Northern Natural Gas Company
1111 South 103 Street
P.O. Box 3330
Omaha, NE 68124-1000
(402) 398-7000

Re: Northern Natural Gas' Response to CPF-4-2020-1007M

In response to the Notice of Amendments dated October 30, 2020, Northern Natural Gas Company submits the following clarifications.

The following flow chart shows how the patrol data flows from the field to the Integrity Management (IMP) risk model.

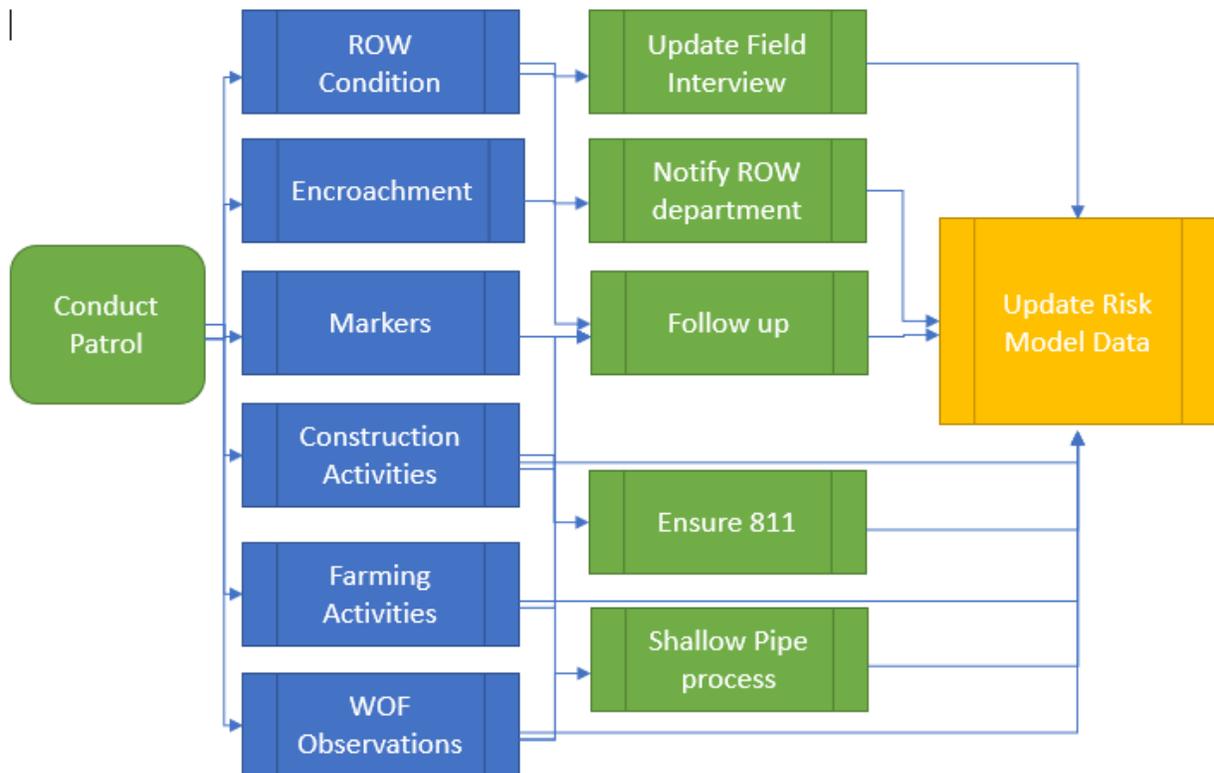
Item 3: § 192.911(c) What are the elements of an integrity management program?

Patrol is the mechanism or task that is used to gather multiple data items that are incorporated into the integrity management program. Operating procedure 80.501, Patrol Program, Section 5.4 lists the types of observations made during patrol, including: class location-construction of new structures along the pipeline, encroachment, leaks, shallow or exposed pipe, construction activity near the pipeline, and presence of markers, pipe or land movement. This data is used to determine class location and presence of high consequence areas in accordance with operating procedures 80.101, Class Location, and 140.101, Identification of HCAs and MCAs.
